January 25, 2021  
**VIA E-MAIL**

Re: ***375 Main Street – Site Plan Approval  
Section 108.03, Block 1, Lot 75***

As you know, we represent NY Fuel Distributors, LLC (the “Applicant”) in connection with the above-referenced property (the “Subject Property”). We respectfully submit herewith the following amended plans and supplemental information for your consideration at your upcoming meeting on February 8, 2021.

PROJECT:  
**PROPOSED SITE IMPROVEMENTS TO SHELL GAS STATION**  
 375 MAIN STREET  
 ARMONK, NY

**EXISTING SITE PLAN**  
SCALE: 1" = 10 FEET

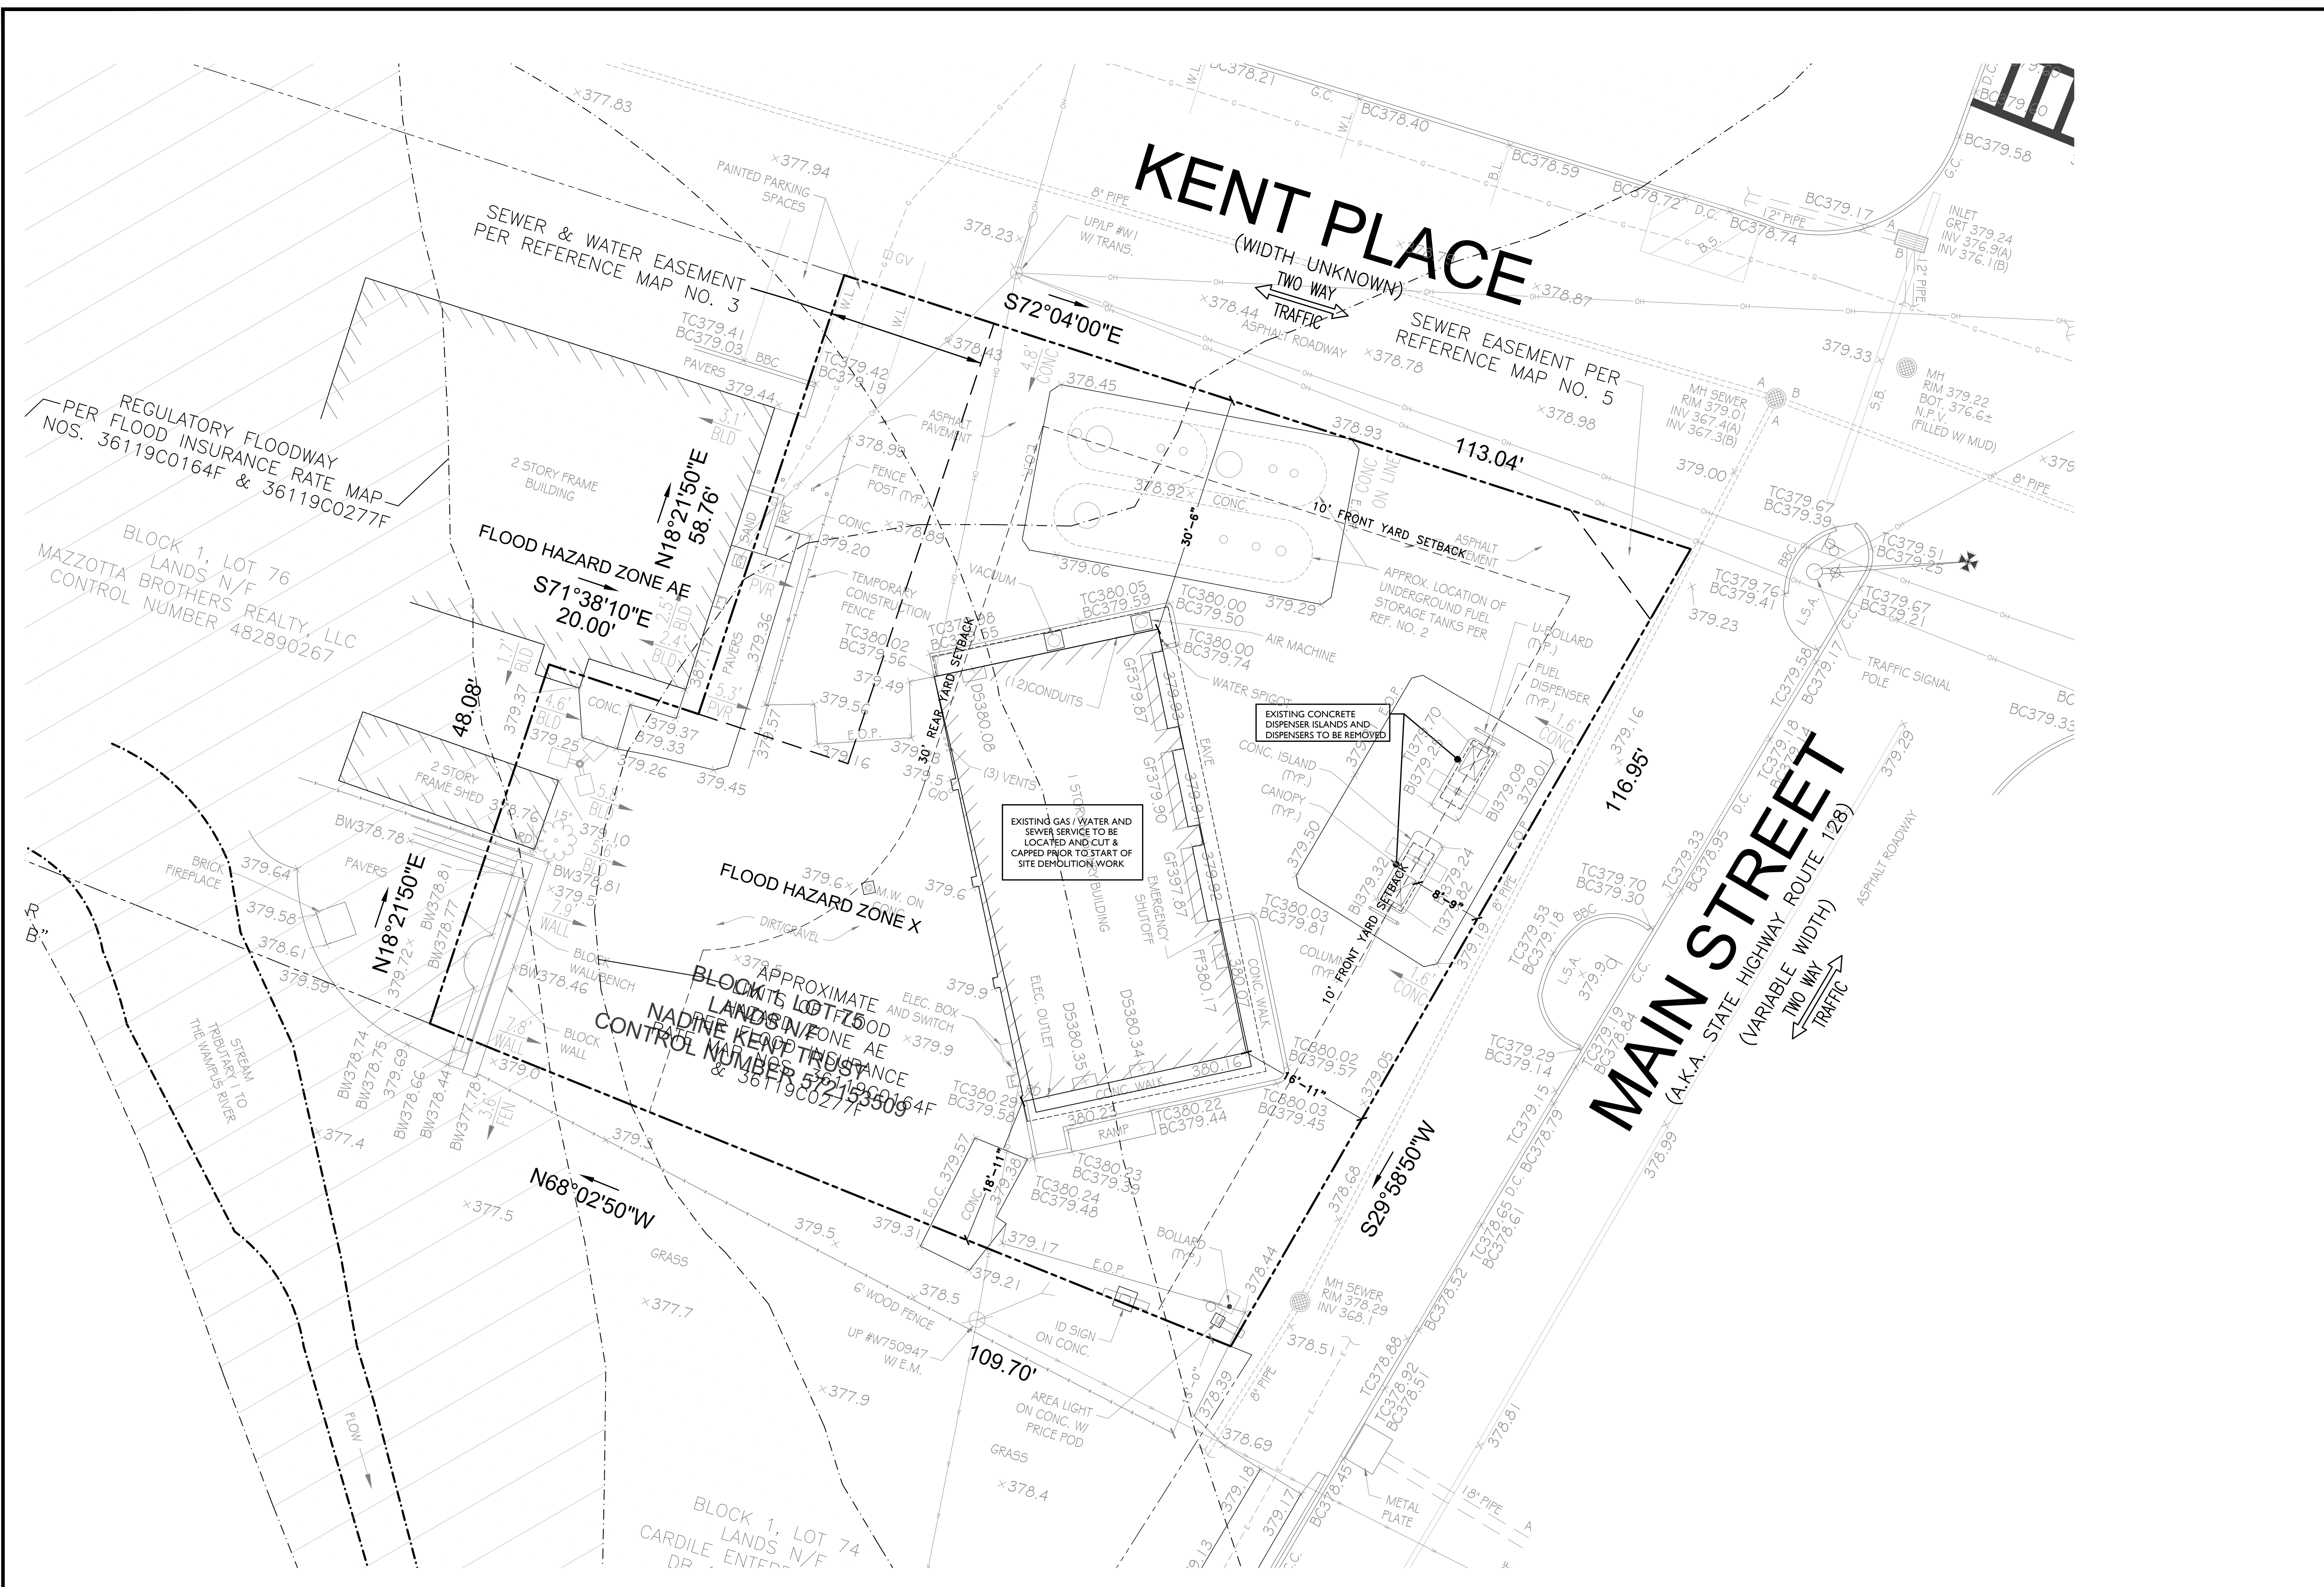
1. *The Existing Site Plan has been expanded, as previously requested, to include all existing, on-site features, as well as those along Main Street, Kent Place and the encroachments from the neighboring Amore Pizzeria, including various walkways, framed storage shed, walls and patio and a portion of the rear of the main building. With the exception of the storage shed, shown to be removed, the applicant provided an updated proposed site plan to show all encroachments to remain, per a license agreement. The Applicant shall provide a draft copy of the license agreement for review by the Town Attorney.*

2. *As previously requested, the Existing Site Plan shall clearly illustrate the limits of all items to be removed, such as curb, sidewalk, fence, etc. The applicant should confirm the ownership and future status of the stockade fence to the south. While it is installed on the neighboring property, it appears to have served the prior service station to screen outdoor storage areas to the rear of the building and may no longer be required.*

5. *As shown on FEMA Firm Panels 36119C0164F and 36119C0277F, effective September 28, 2007, the property is located partially within a FEMA Floodplain and Floodway, Zone AE, with an Elevation of 379. As previously requested, the floodplain and floodway boundaries and associated elevations shall be illustrated on the plan with references to the effective FIRM Maps. A Floodplain Development Permit will be required. The plan must demonstrate compliance with Chapter 177, Flood Damage Prevention of the Town Code, specifically, as it relates to encroachments within a floodway, compensatory storage volume and elevations of buildings and utilities. Section 177-17.A of the Town Code requires that the lowest floor be elevated to at least two (2) feet above the base flood elevation; or be floodproofed so that the structure is watertight below two feet above the base flood level. The plan proposes the floor elevation at Elev. 380.5, requiring that the building be floodproofed. The Applicant shall note the base flood elevation on the proposed site plan and elevation of the of the proposed flood proofing/flood gates. The applicant shall provide a construction detail of the proposed flood gates and a cut/fill analysis to demonstrate no net loss in flood storage in the flood plain.*

a. The Applicant has entered into a license agreement with the neighboring property owner to remove the stockade fence and utilize a portion of the neighboring property for construction staging and landscaping. A copy of the license agreement has been provided to the Town Attorney.

- a. The floodplain and floodway boundaries and elevations are now shown on the existing and proposed site plan. The Applicant has removed any encroachment from the floodway and appropriate details and information have been added to the plan. With the updated survey information the proposed building is actually outside of the floodplain. The Applicant will work through any required floodproofing with the Town Engineer and Building Department during the building permit review process.
